PRODUCT NEWS BULLETIN

PN348081006

Product Improvement Link Pivot Pin

Applicable to all Carter brand Model 64348 Commercial and Models 64049 & 64349 Military Nozzles

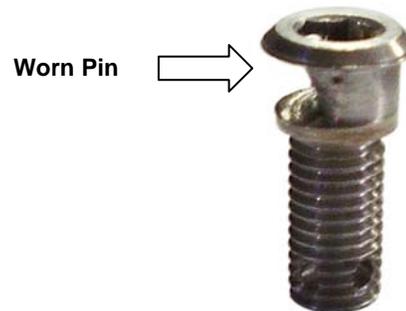
A key part of the 64348/64049/64349 family of nozzles has been redesigned to lengthen its life. The 220886 Pin (Item 31 Figure 2 of SM64348, SM64049, & SM64349) is part of the opening/closing mechanism. The material from which this part is made has been changed and hardened to reduce wear. The earlier design Pin was made of a 300 series corrosion resistance steel that can not be hardened. The new Pin will be made of A286 Corrosion Resistant Steel per AMS 5731 or AMS 5737 and hardened to C30 Rockwell.

The existing Pin has not changed since the 64348/64349 family of nozzles went into production back in 1992, but there have been several cases of excessively worn Pins discovered recently. Although this pin is subject to normal wear from continual use, wear is accelerated on the pin by even slight "over" adjustment of the position of the poppet to stop/prevent poppet leakage. This adjustment is currently outlined in paragraph 8.1.4 of all three service manuals as follows:

This Pin is manufactured from a commercially available aerospace standard screw made of 300 series corrosion resistant steel, and recent Pins may have been made from a lower grade than those made previously. Owners of Model 64348, 64049 or 64349 Nozzles less than a year old may obtain a no charge replacement by providing their local Carter distributor with the serial number of their nozzle(s) in question. The following serial numbers qualify:

"Bearing diameter of item 31 Pin (.300 inches (7.62 mm) diameter min.)"

Additionally, if a nozzle requires repeated Poppet adjustments to prevent Poppet leakage, further inspection of this Pin should be completed to ensure that the problem is not being caused by a worn Pin.
